ALTERATIONS TO CONDITIONS OF ASSIGNMENT OF LOADLINES

Ship's Name KENRYU MARUOfficial No. 67584Port of Registry KOBEThis ship has been under survey at Osakaon 13 - 21 July 55 195 and the following alterations to the conditions of assignment of loadlines have now been effected/found:—Alteration to No 2 Hatchway on upper deck.

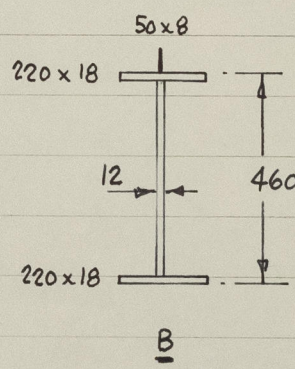
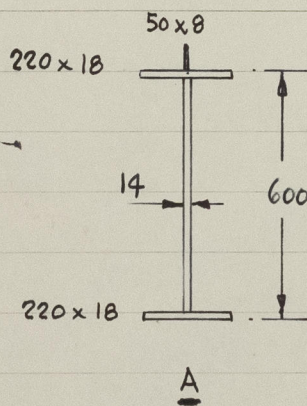
No. 2 steel hatch covers have now been changed to wooden hatch covers, and hatch has been rebuilt as shown below:—

DESCRIPTION No 2 Cargo hatch. Upper deck.DIMENSIONS 21.450 x 6.400 m.COAMINGSHt. above deck 740 mm.thickness { sides 12 mm.
endsStiffeners 250 x 90 x 12 BA. horizontal.Brackets 9 mm. plate, flanged 90 mm, spaced 1.650 m.BEAMSNumber 16Spacing 1.275 m.Bearing surface 150Beams A & B fitted alternately
(8 of each)COVERSMaterial Wood.Thickness 60 mm.Fitted F & A.Bearing surface 100 mm.BATTENING ARRGT'SCleats, battens, tarpaulins, & locking bars provided in accordance with Rules.A copy of this Report has been placed on board.
